| Machine: <b>MMx 43B/ 50B</b>                                    |
| Subject: <b>Geared motor with threaded axle</b>                 |

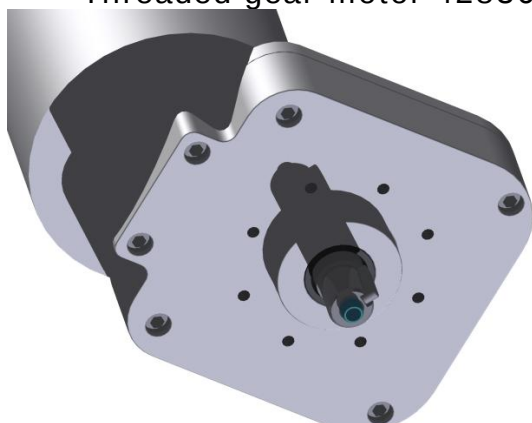
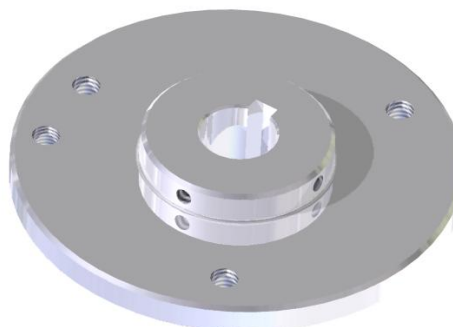
To reinforce the locking system of the flange to the brush motor this one has been replaced with a new one that has a threaded axle. The motor can be installed on machines older than the daPer rafforzare il sistema di aggancio della flangia ae indicated.

| ADD  |        |                               |
|------|--------|-------------------------------|
| 1    | 428364 | Gear motor. 24V 400W threaded |
| 1    | 217521 | Threaded flange               |
